November 14, 2014

**BOARD OF COUNTY COMMISSIONERS
ORANGE COUNTY, FLORIDA
ADDENDUM NO. 2 / IFB Y15-721-EZ**

**ORANGE COUNTY CLARCONA HORSEMEN'S PARK KITCHEN AND REC BUILDING HVAC
REPLACEMENT**

Drawing Title:
**EXTERIOR
ELEVATIONS
DEMOLITION**

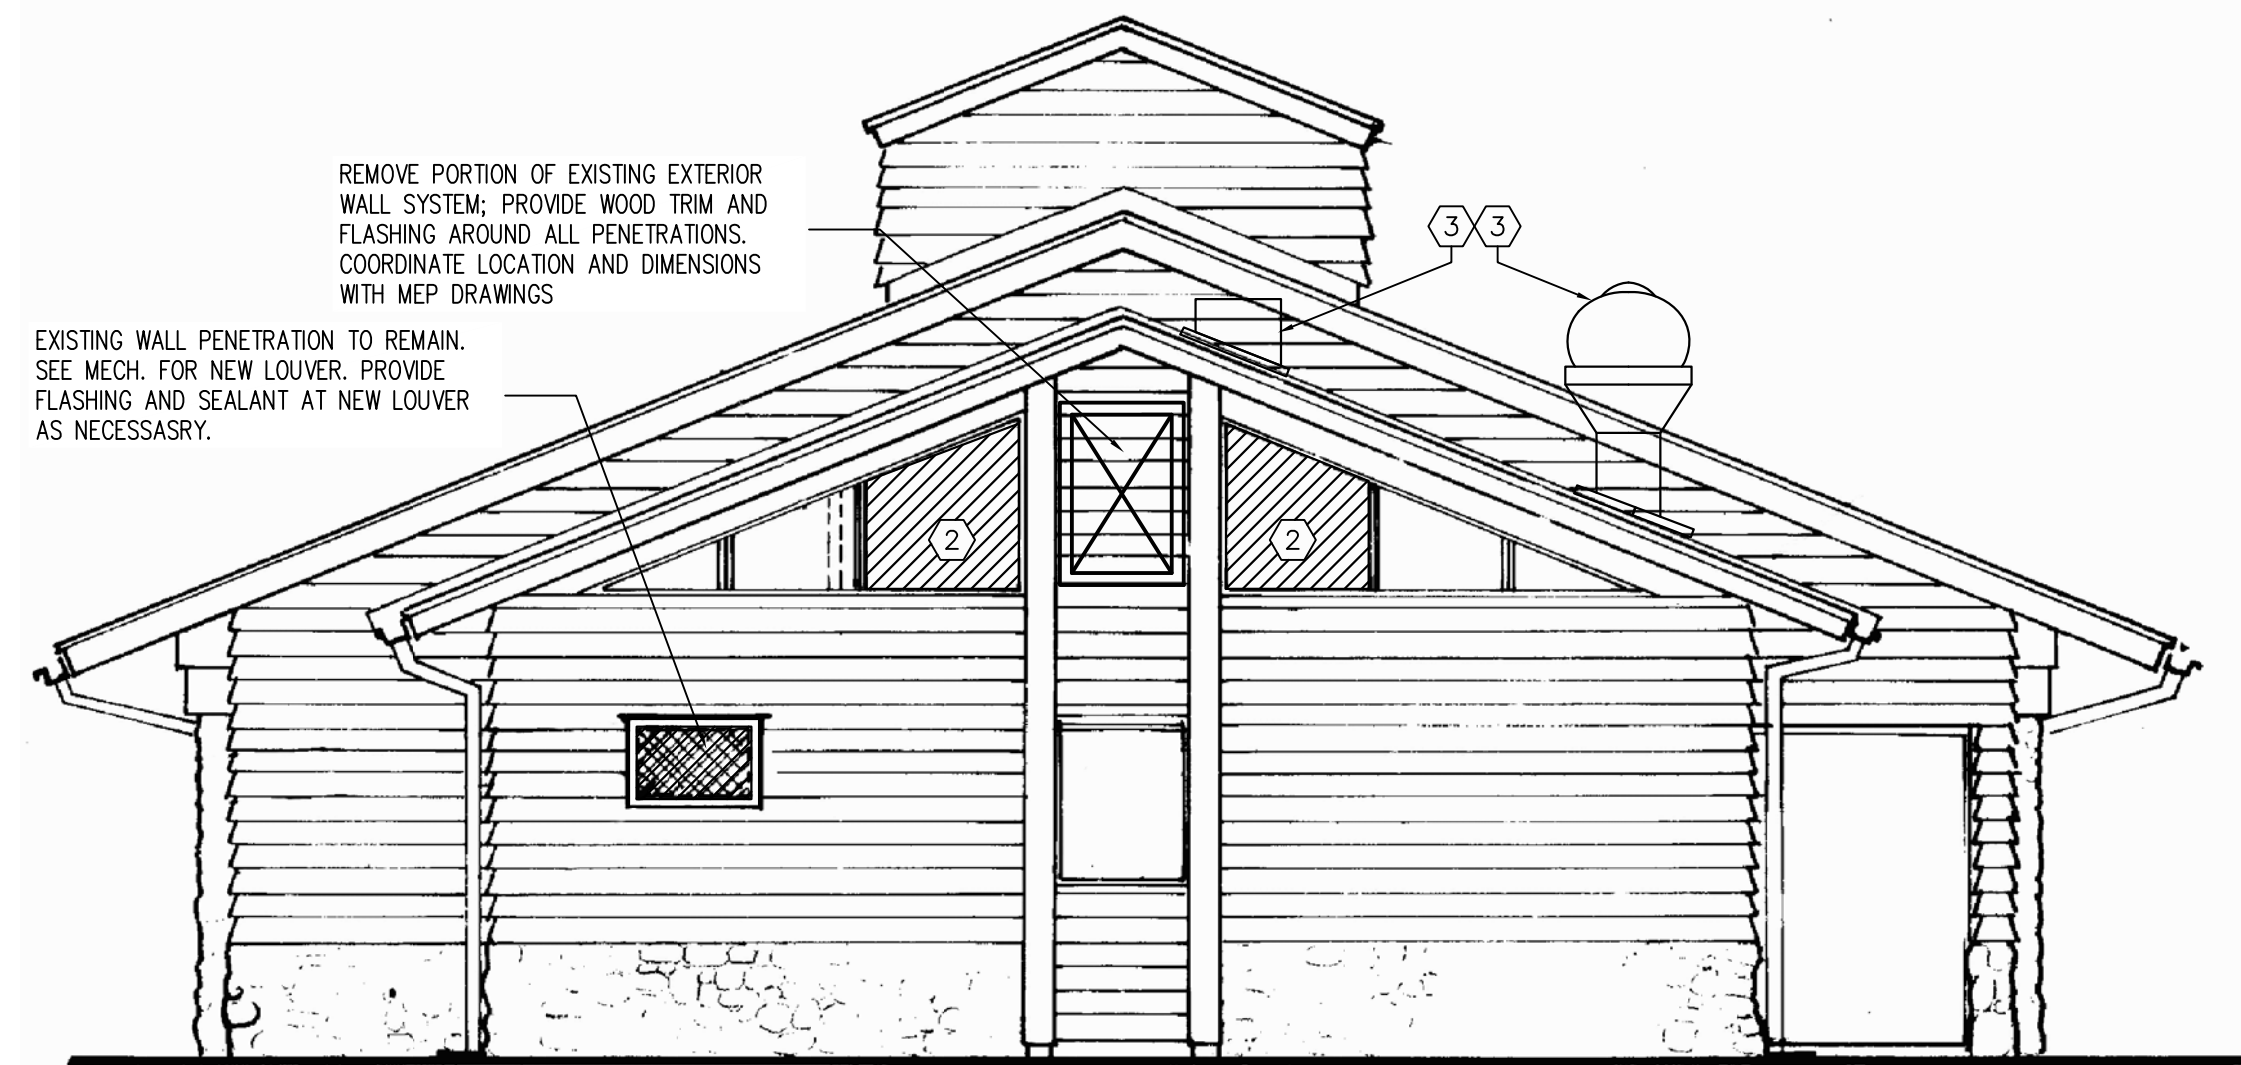
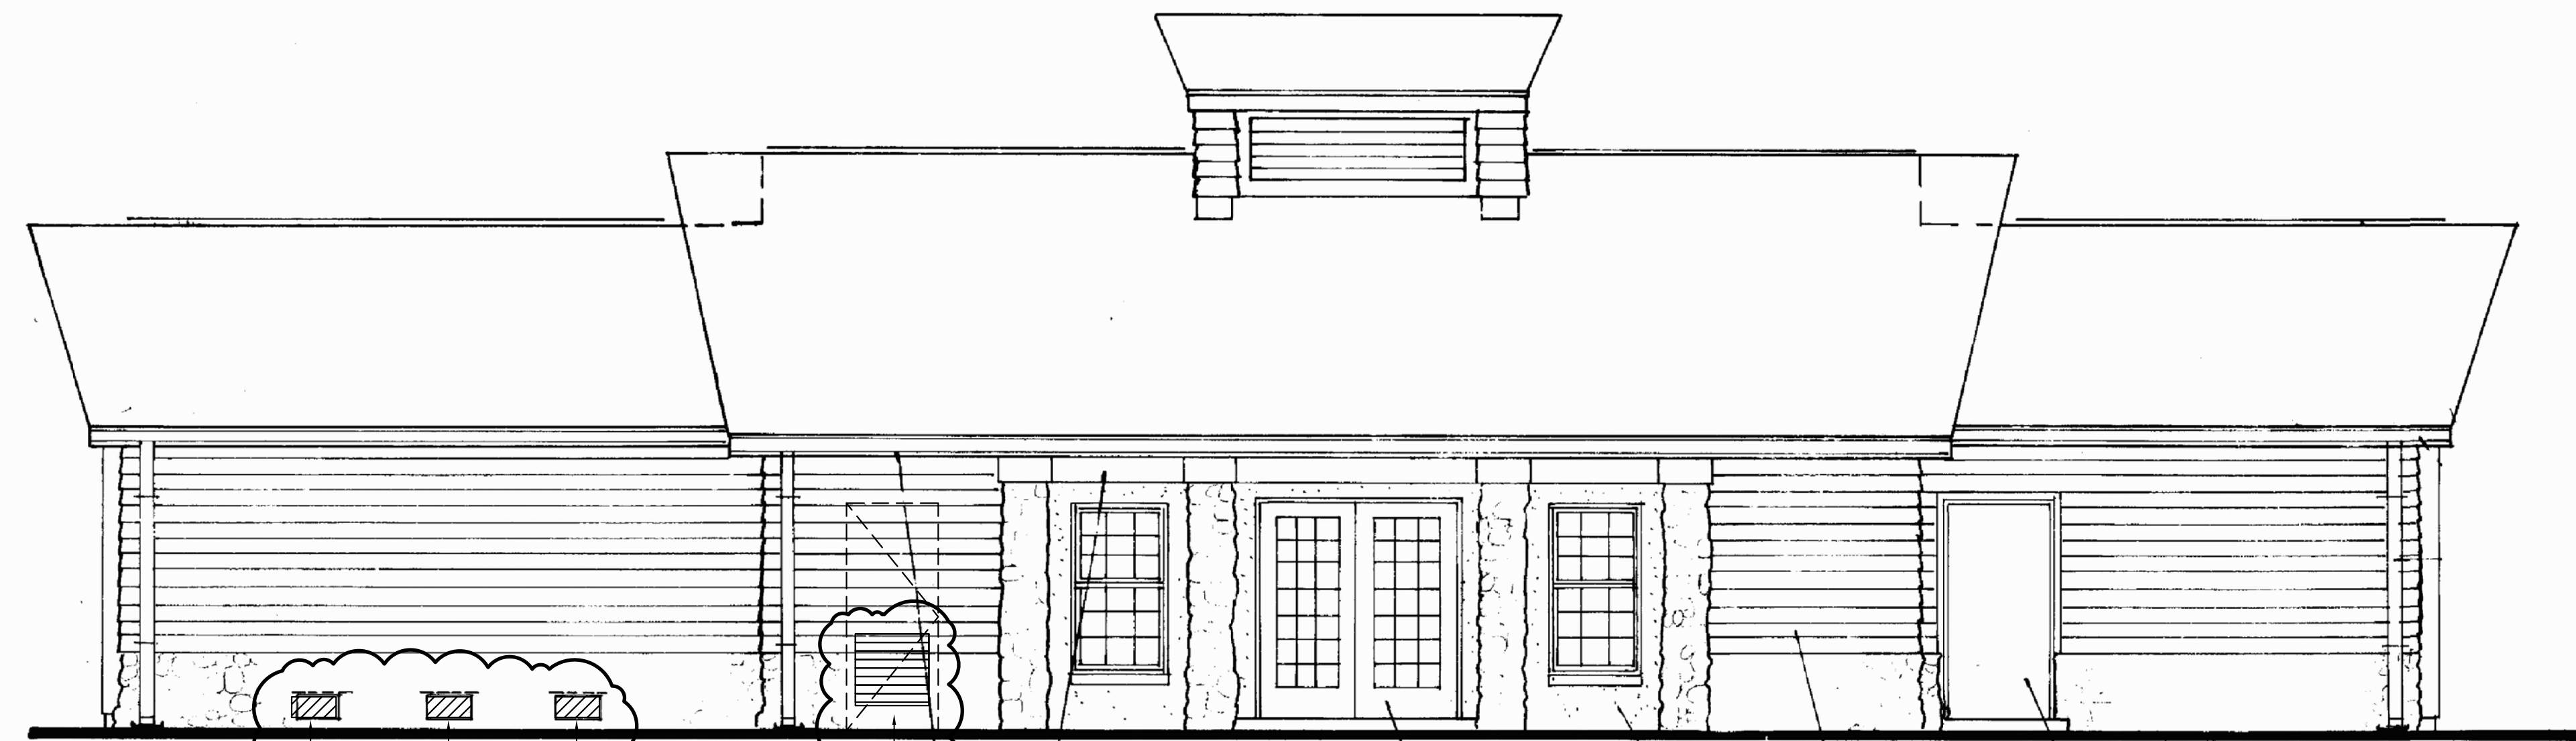
- (1) Revise Hex Notes 1, 4, and 5.
 - e. DRAWING SHEET NO. A101 – FLOOR PLAN - RENOVATION - ARCHITECTURAL
 - (1) Revise Hex Notes 1, 4, and 5.
 - f. DRAWING SHEET NO. A102 – REFLECTED CEILING PLAN – RENOVATION - ARCHITECTURAL

1 REFLECTED CEILING PLAN - RENOVATION - ARCHITECTURAL
SCALE: 1/4" = 1'-0"

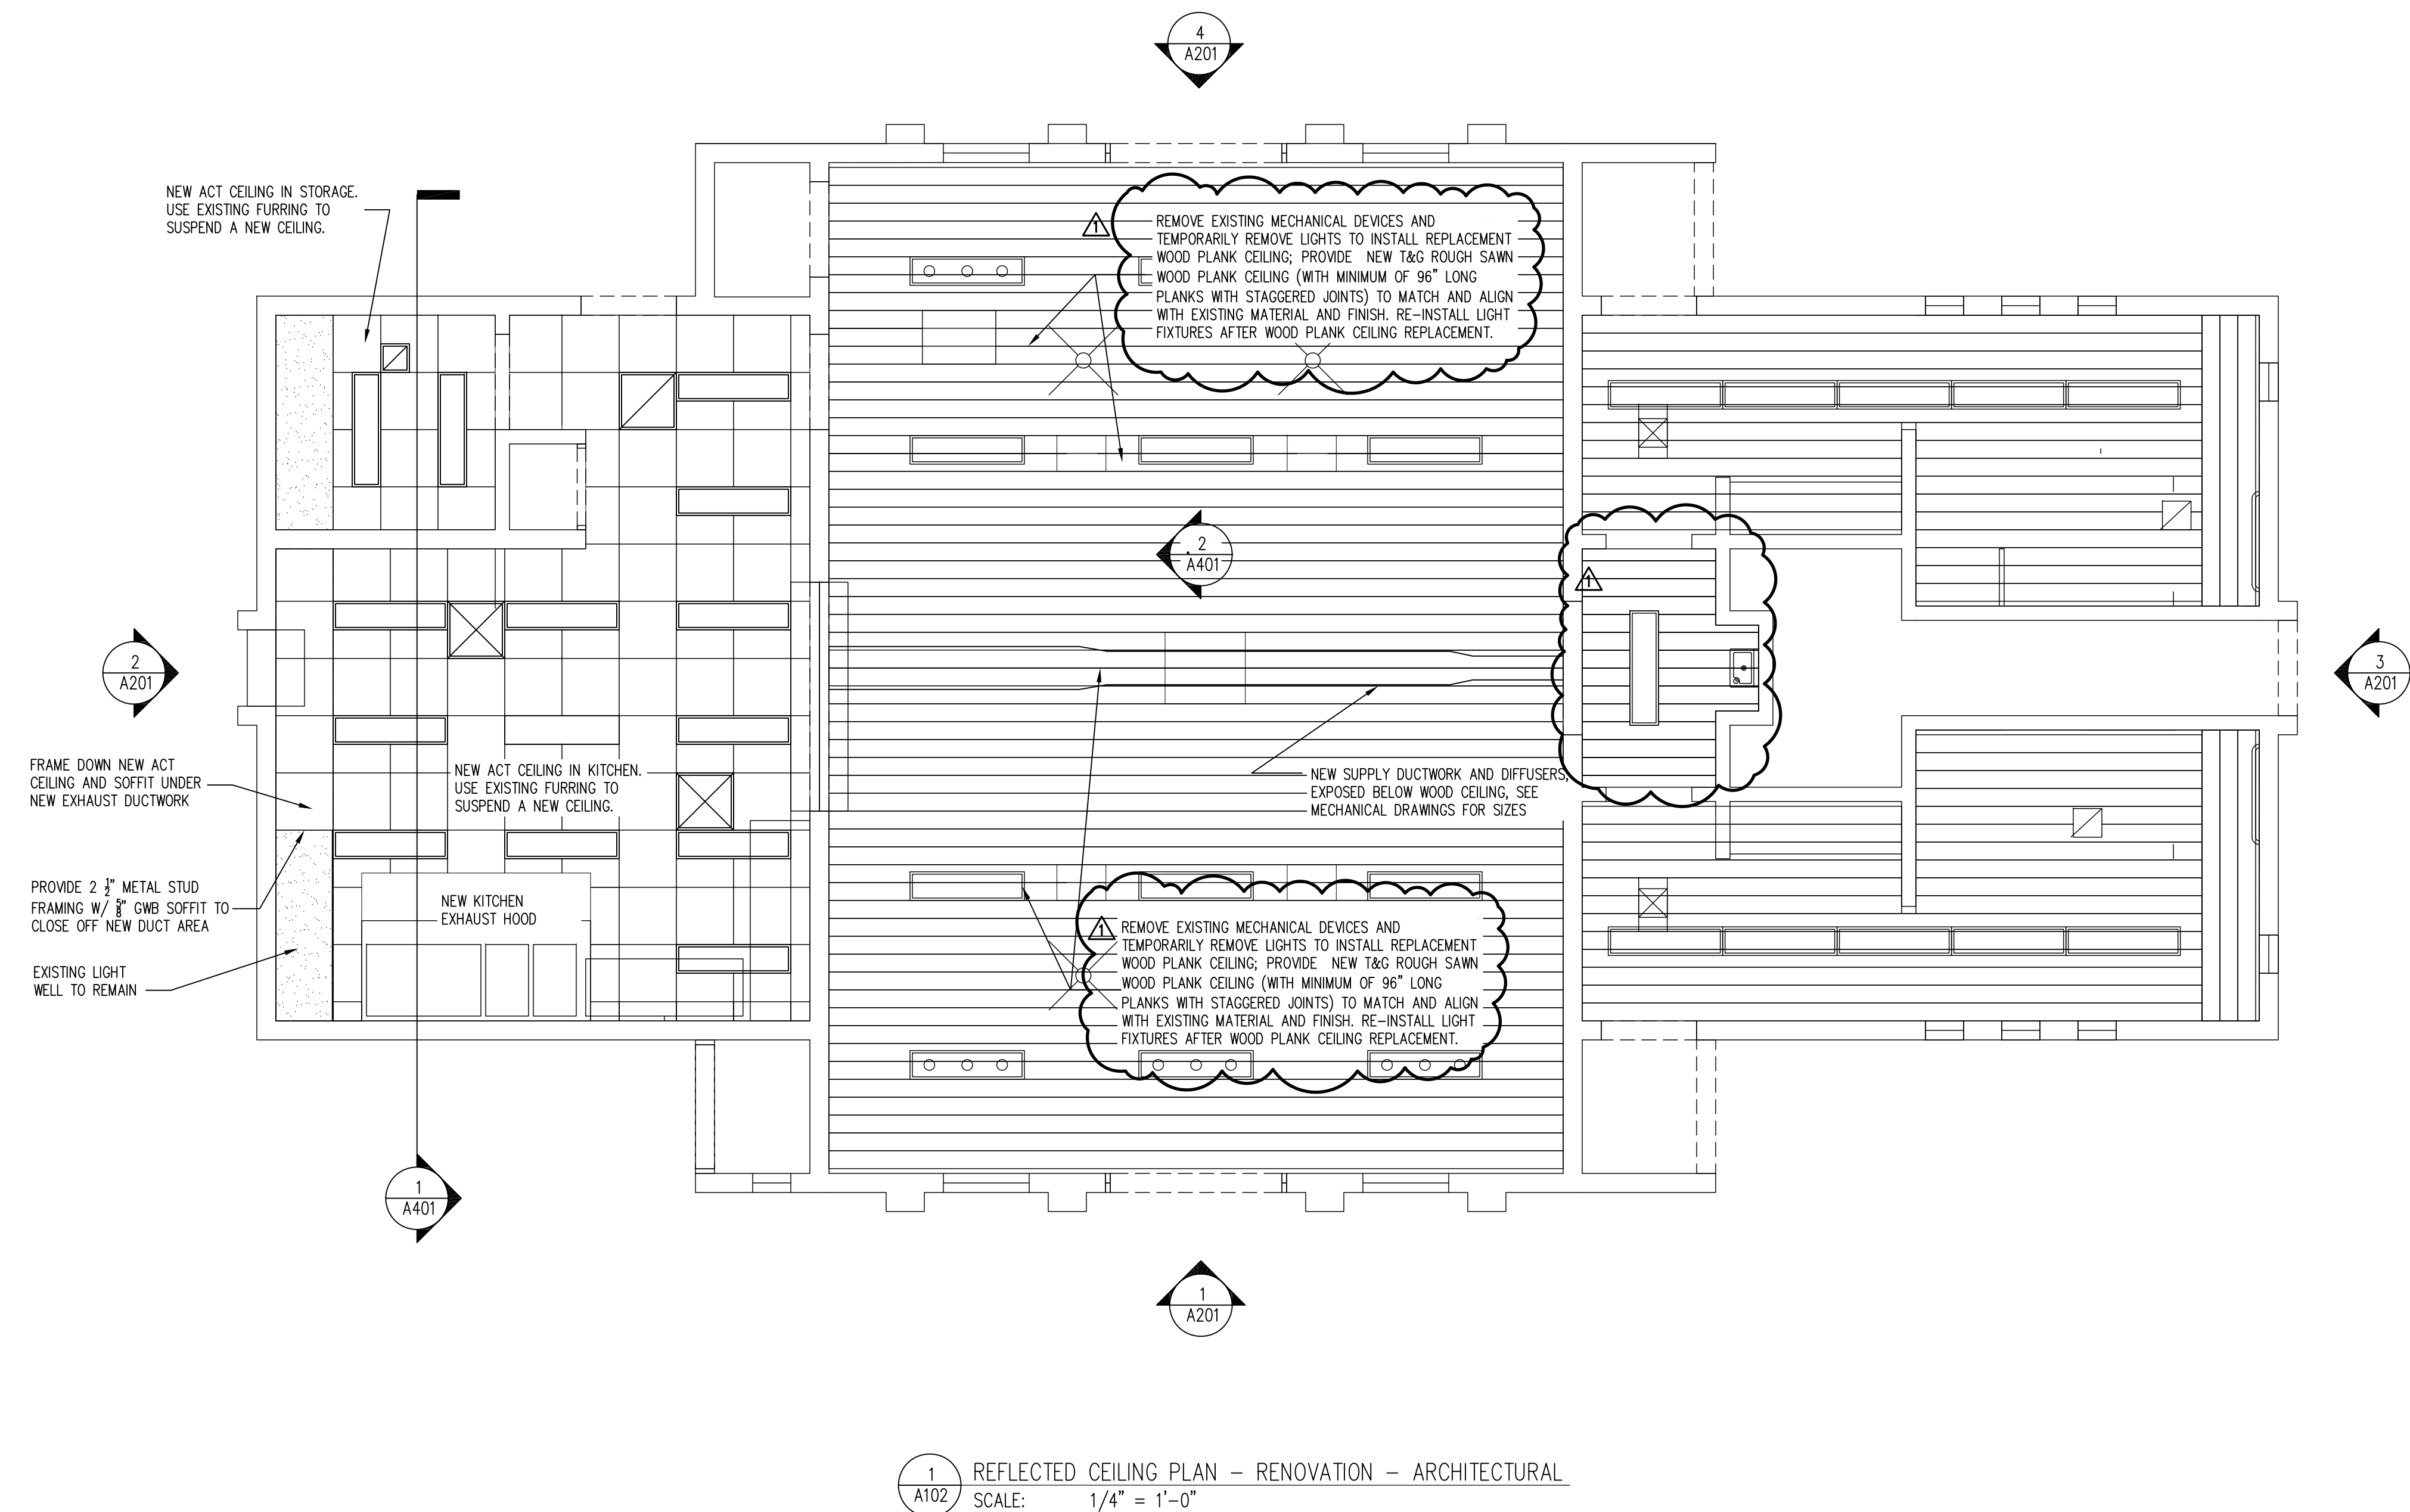
- (1) Revise Hex Notes 1, 4, and 5.
 - (2) Revise notes for demolition of existing ceiling devices.
 - g. DRAWING SHEET NO. A103 – ROOF PLAN – RENOVATION - ARCHITECTURAL

1 A103 ROOF PLAN - RENOVATION - ARCHITECTURAL
SCALE: 1/4" = 1'-0"

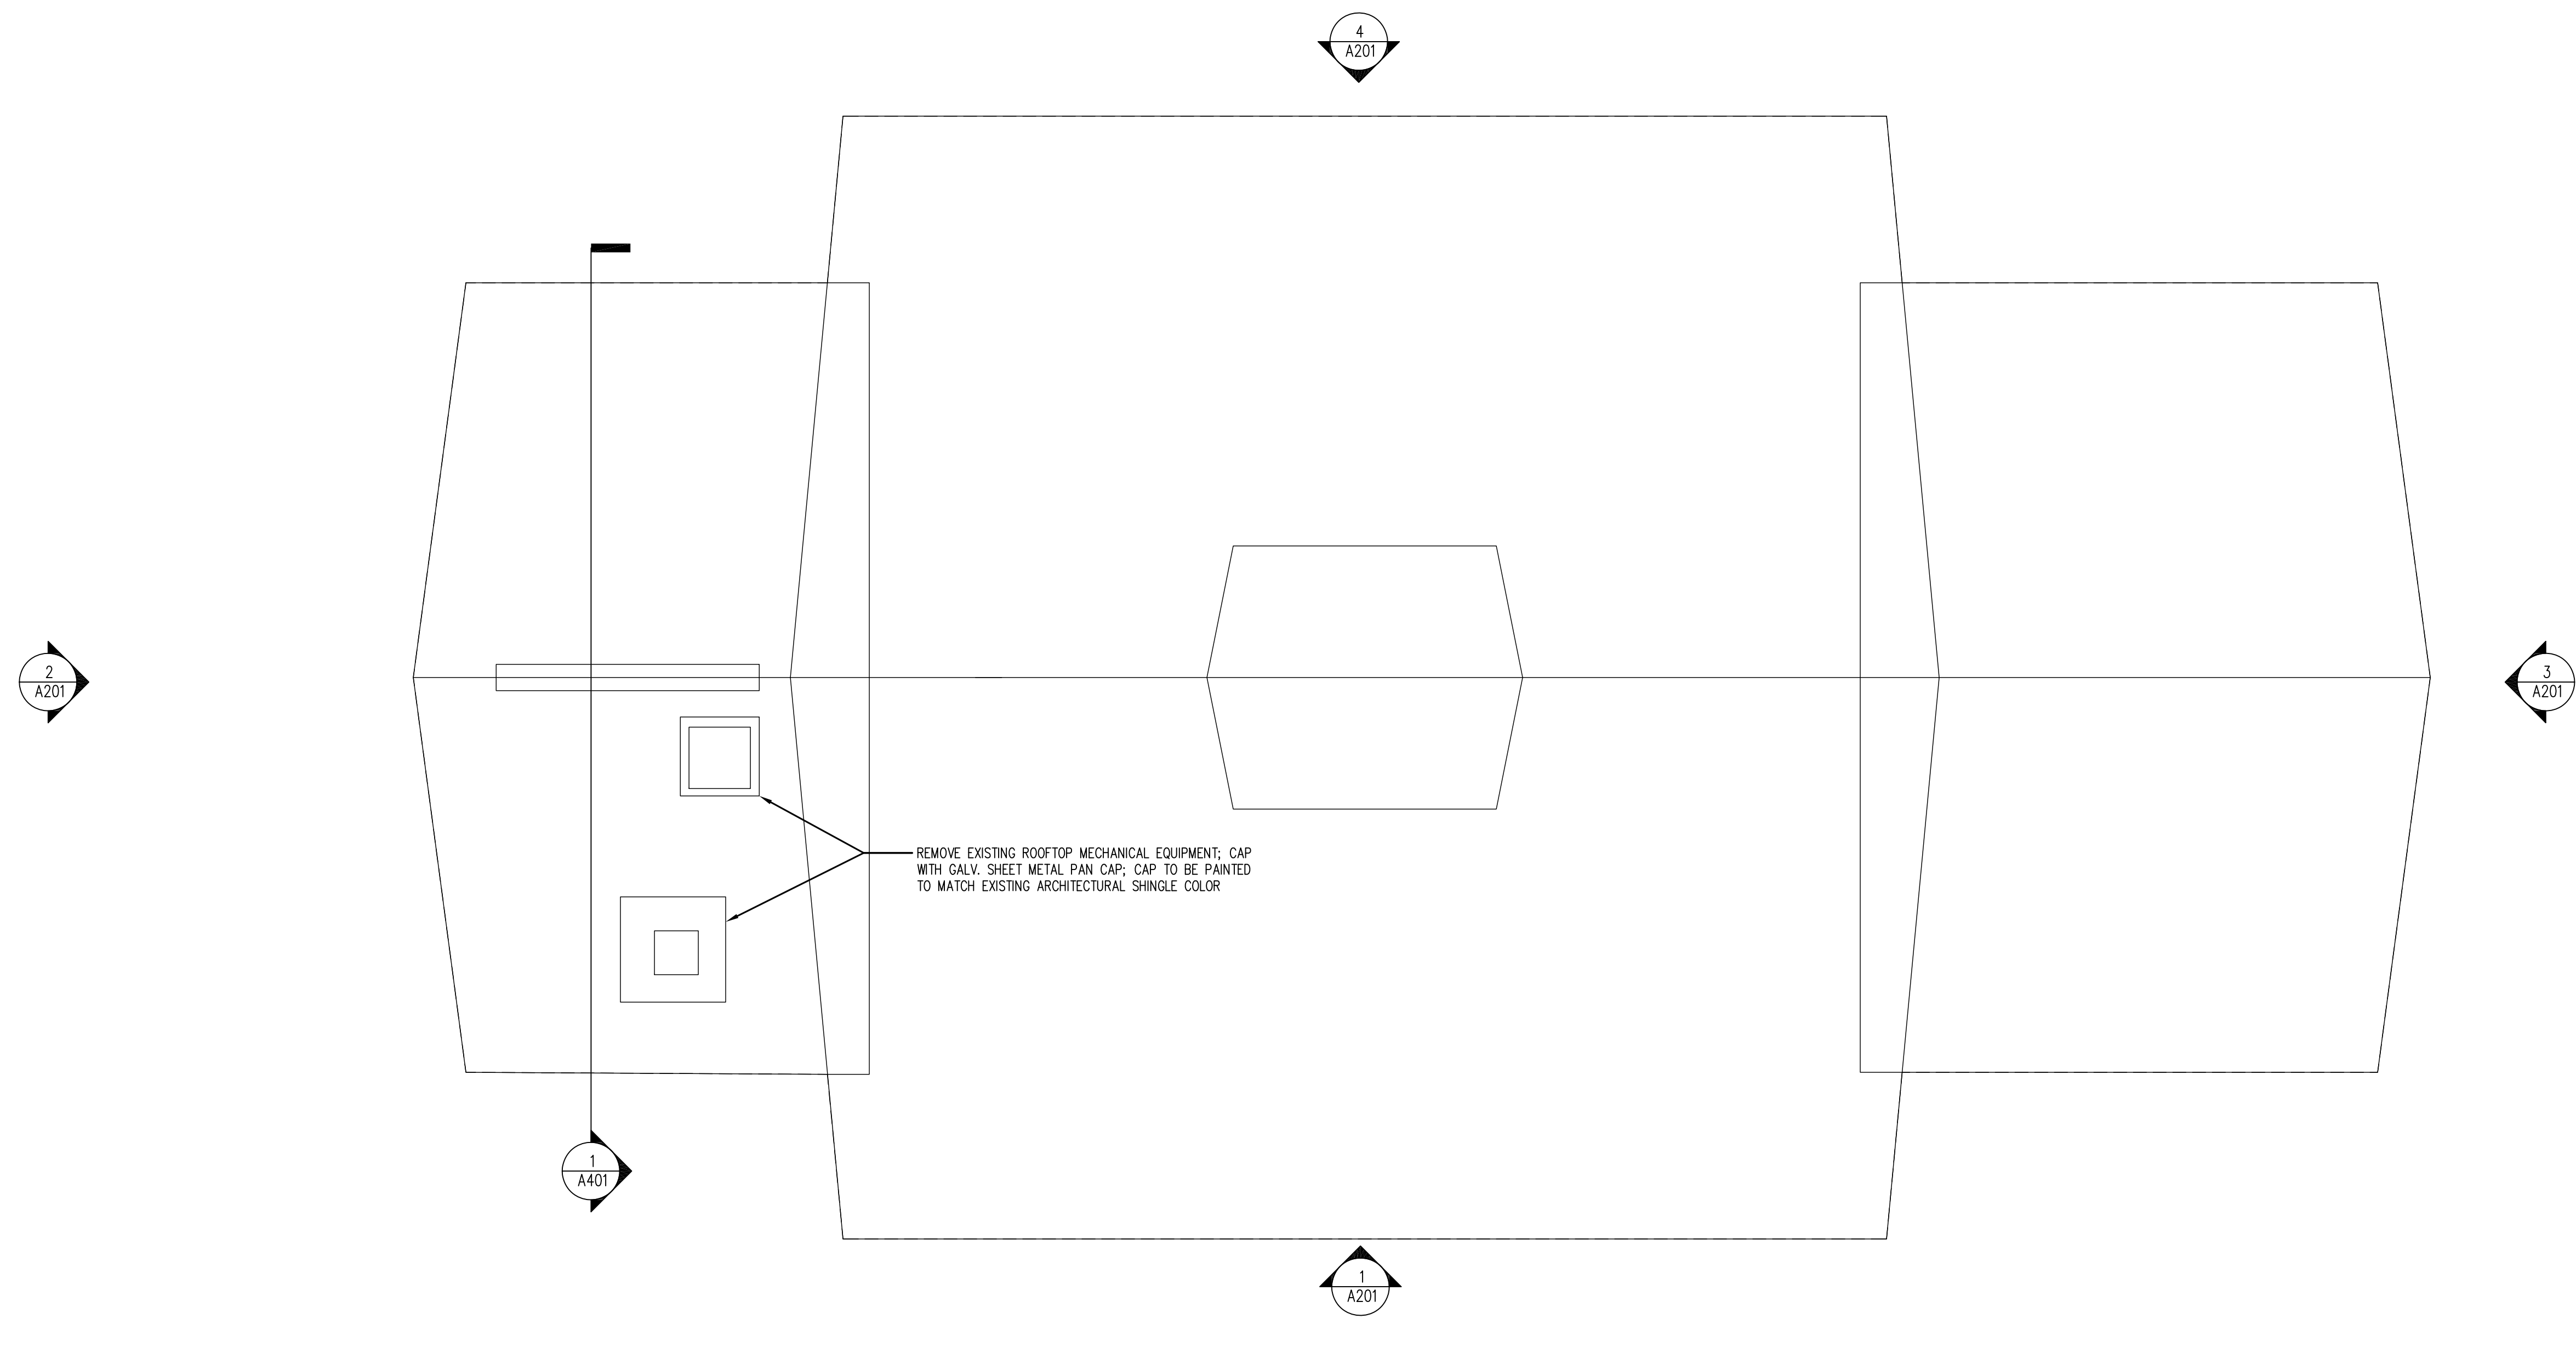
- (1) Revise Hex Notes 1, 4, and 5.
 - (2) Revise notes for demolition of existing ceiling devices.
